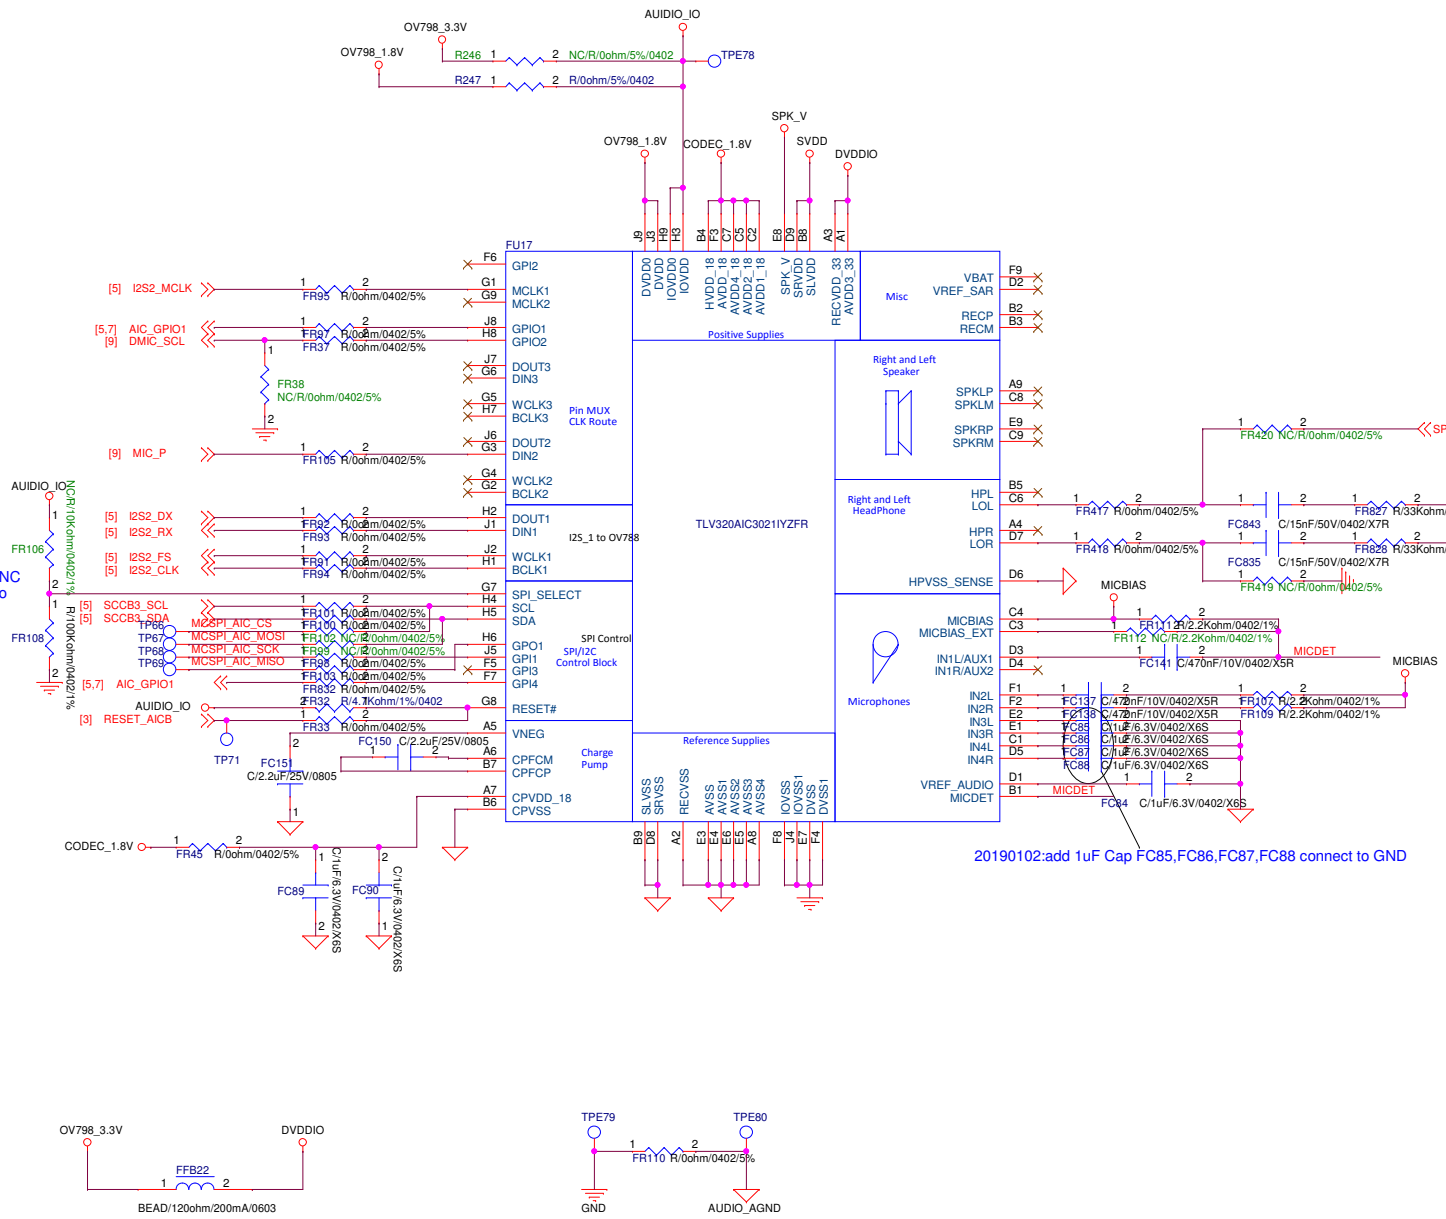
20181218:change AUDIO_IO from 3.3V to 1.8V

20190108:change FR106 to NC for using I2C instead of SPI to configure the audio code

20190110:add the factory test point TPE86 TPE88 for speaker
20190117:change FFB20,FFB21 from BEAD/120ohm to R/0ohm
20190119:change FFB20,FFB21 from R/0ohm to BEAD/120ohm

20190103:change C1028 from 1nF/0201 to 1nF/0402
20190306:change the enable pin of FU801 to SPK_VDD, and add a 100nF cap FC854

20190102:add 1uF Cap FC85,FC86,FC87,FC88 connect to GND

20181218:change all U1122 related components to NC
20190306:change FR831 & FR834 to install, add a 0ohm resistor R249 of SPK_SHDN, and reserve a 0ohm resistor R251 of OV_PWR_EN_1 for U1122 enable
20190307:move FR829 connect to ground, move FC854 to U1122.8, and change R249 to NC, change R251 to install

20181218:add FR835 for AMP power
20190306:change FR835 to NC

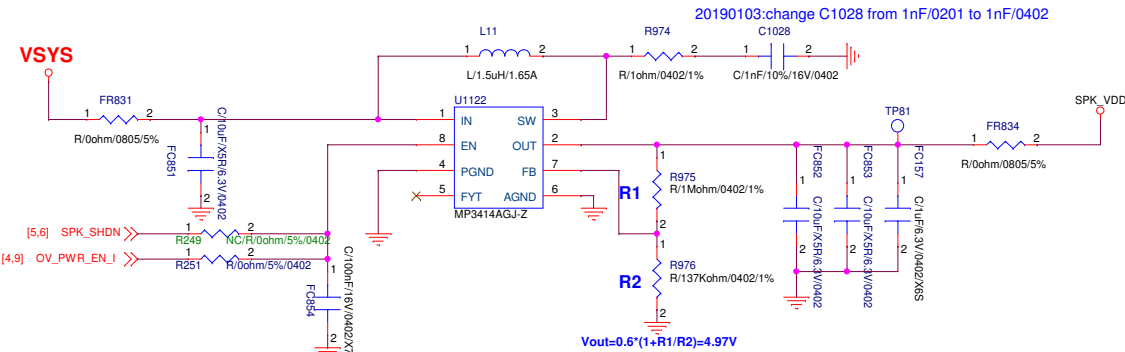
for Speaker PA 5V power
